Beachlands South

Fast-track Application

Response to s67 Request for Futher Information

07 September 2026

Vehicle Crossings and Pedestrian Continuity

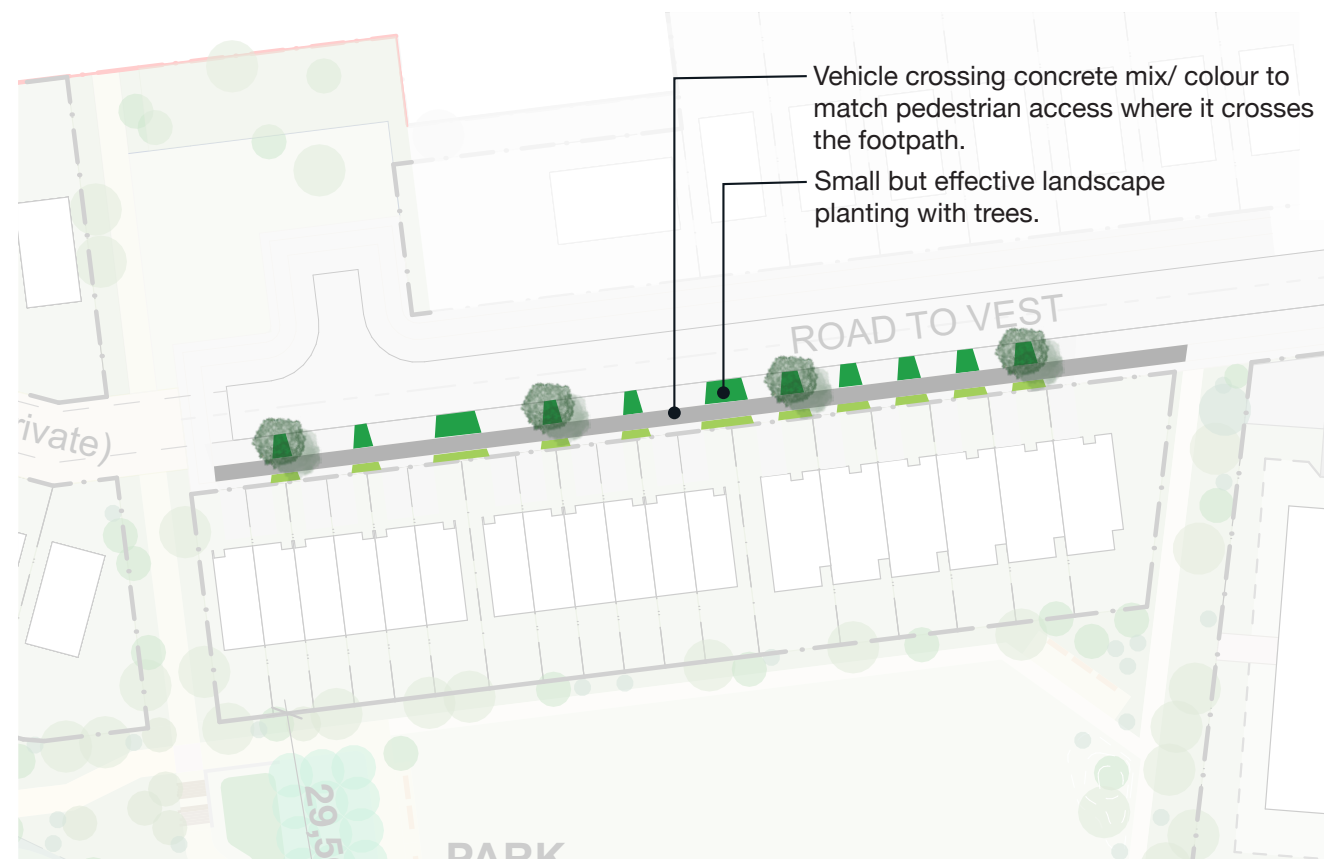
Several residential frontages include frequent individual vehicle crossings. Among these, MP2 has the highest concentration of vehicle crossings, where the street-facing pedestrian footpath is heavily interrupted by repeated driveway crossings.

1. Please clarify whether opportunities to consolidate or reduce vehicle crossings at MP2 have been considered, and how the proposed arrangement maintains pedestrian continuity, safety and amenity along the street edge.

Please provide the underlying rationale for the queries raised in the urban design report regarding the high concentration of vehicle crossings that disrupt continuous pedestrian flow under ‘Vehicle Crossings and Pedestrian Continuity’.

The information is vital from a pedestrian safety perspective to minimise vehicle-pedestrian collisions, especially affecting vulnerable pedestrians such as children biking in and out of the apartments, elderly residents, caregivers of young children, and people using micromobility devices on footpaths. Minimal vehicle crossings and safety measures in place, such as high-visibility design, champion pedestrian priority and a walkable street environment in general.”

To maintain pedestrian continuity, safety and streetscape amenity within MP2 and other similar terraced housing clusters, we have:

- Consolidated vehicle crossings where practicable to reduce interruptions along the footpath.
- Prioritised pedestrian continuity by maintaining a consistent concrete mix and colour across the footpath where it crosses vehicle access points, reinforcing the pedestrian route as the continuous element.
- Maximised limited landscape areas through the careful selection and placement of trees and shrubs to provide greenery, visual relief and improved streetscape amenity, while maintaining clear sightlines around footpaths and vehicle crossings to support the safety of children, cyclists and other vulnerable users.

MP1-A

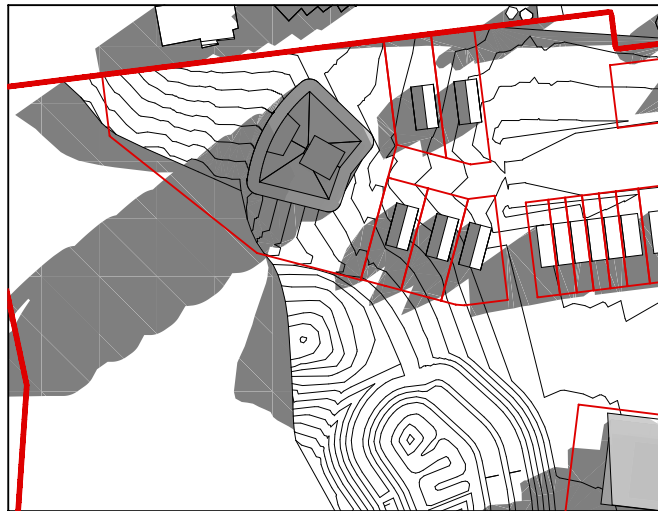
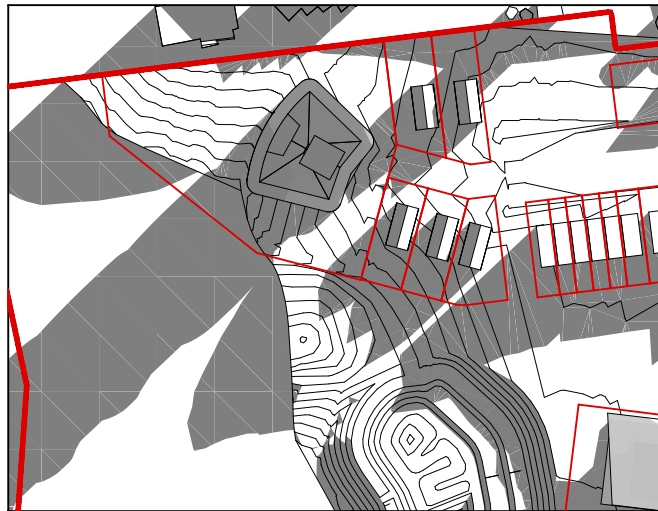
1. Please identify whether any shading/sunlight analysis has been undertaken for the key taller buildings. It would also be useful to provide appropriate targeted sections through the relevant sub-precincts and 3D model views that clearly show the height relationship between the proposed taller buildings, particularly those exceeding the anticipated height, and surrounding built form.

3 - C1-A (SECTION B-B) - 1:750

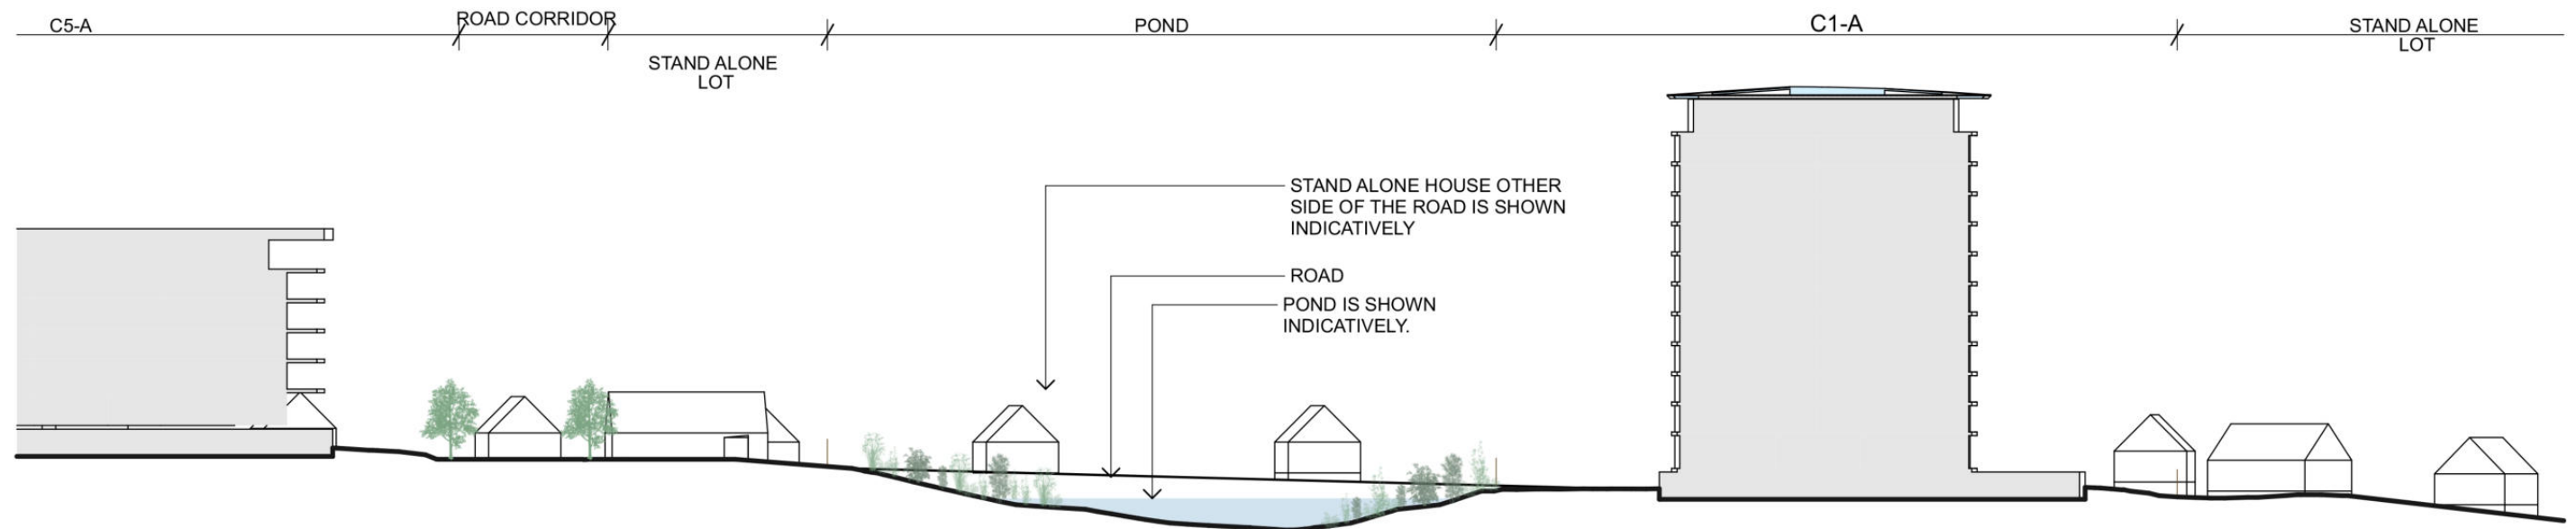
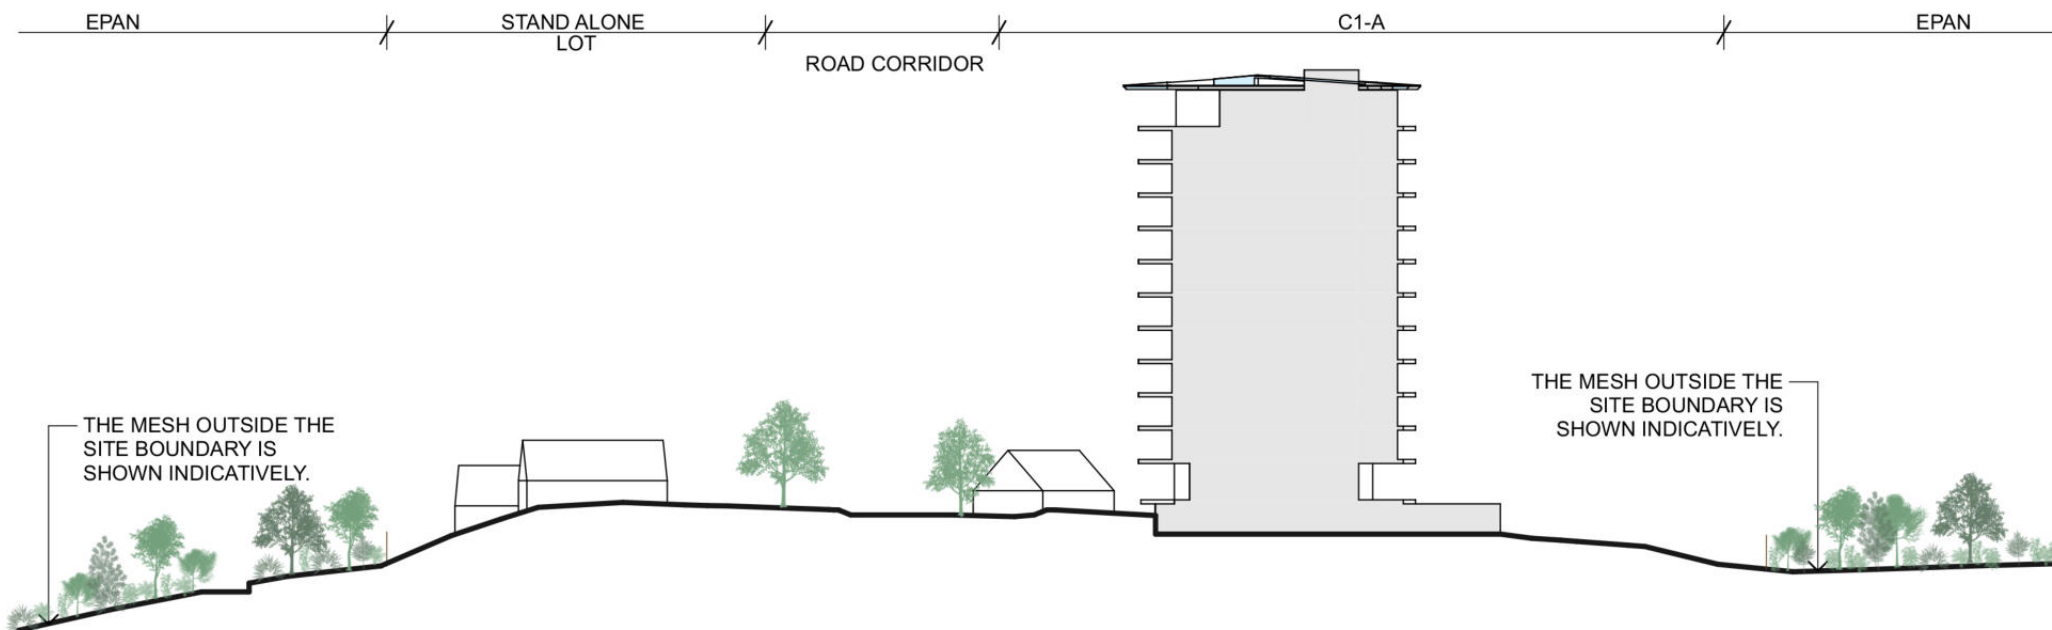
1. Please identify whether any shading/sunlight analysis has been undertaken for the key taller buildings. It would also be useful to provide appropriate targeted sections through the relevant sub-precincts and 3D model views that clearly show the height relationship between the proposed taller buildings, particularly those exceeding the anticipated height, and surrounding built form.

Open Space Overview Plan

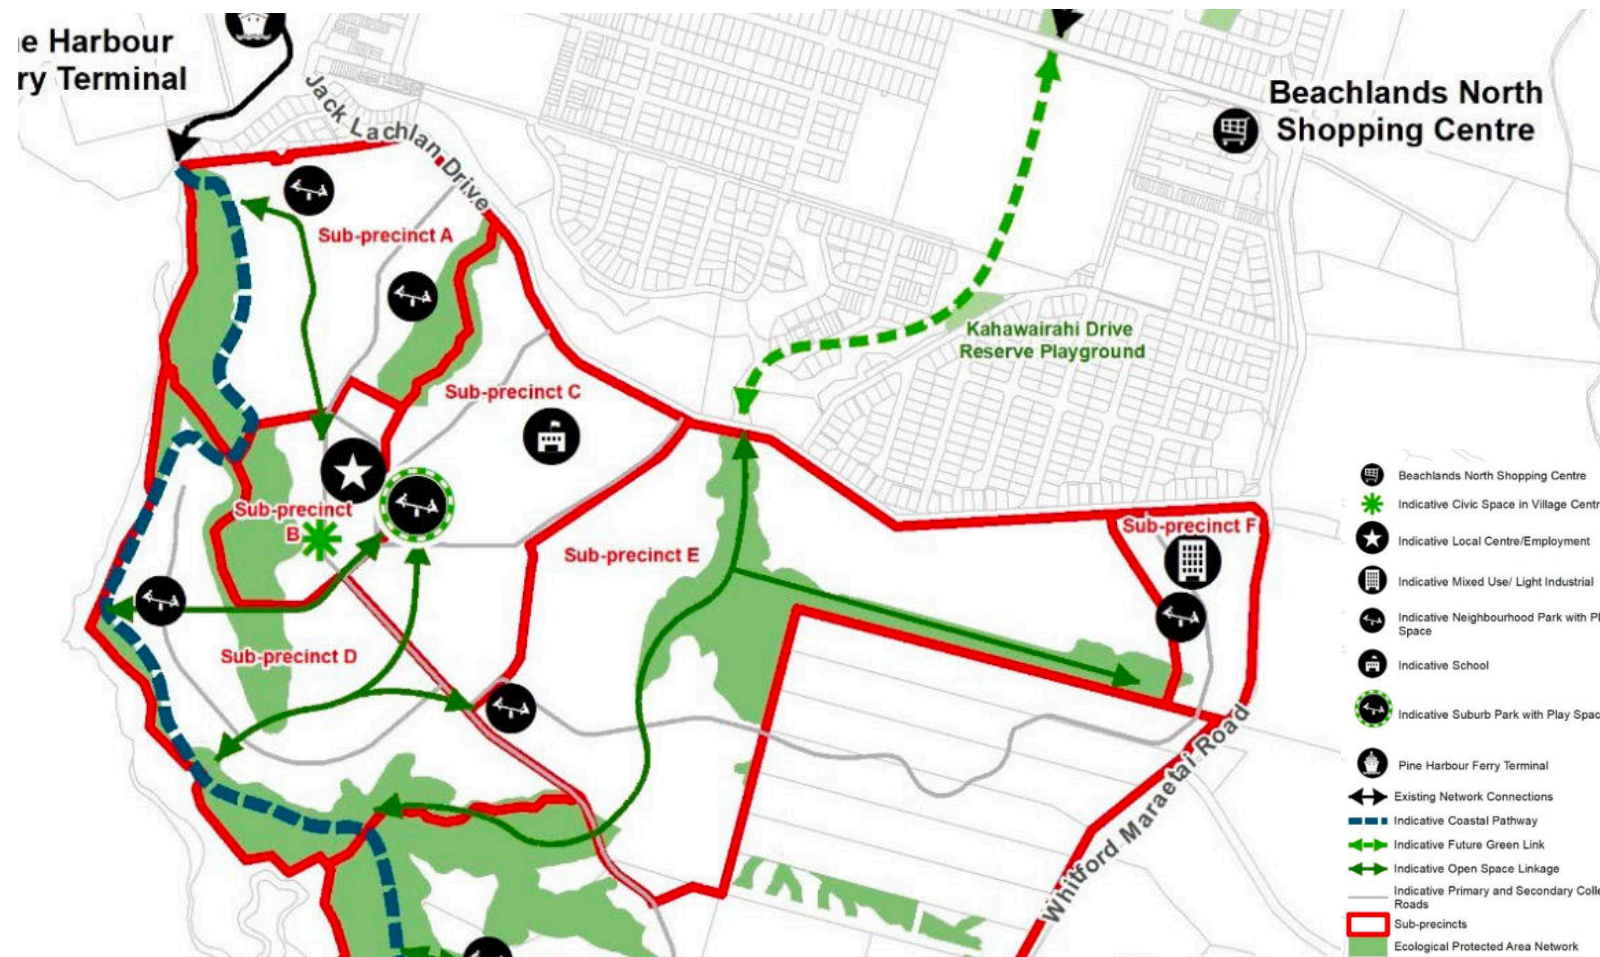
The provision and distribution of public open spaces across the development and their function need further clarification and resolution.

1. Please clarify how the proposal responds to the open-space linkages and green links shown as Structuring Elements on Precinct Plan 3 (I458.10.3), including the indicative connection between the Sub-precinct D EPAN and the Sub-precinct C suburban park, which does not appear to be clearly replicated in the proposed layout.

2. Where any linkage has been relocated, altered or omitted, please clarify how its intended connectivity and movement function is otherwise achieved.

The Open Space Overview Plan has been updated to more clearly identify the pedestrian and green links across the development, including the indicative connection between the Sub-precinct D EPAN and the Sub-precinct C suburban park, consistent with the connectivity shown on Precinct Plan 3.

Where the exact alignment of a linkage differs from Precinct Plan 3, the proposed layout maintains its intended connectivity and movement function through alternative pedestrian and open-space connections. These links provide continuous and legible connections between the key open spaces and surrounding precincts.

Please refer to the updated Open Space Overview Plan below.
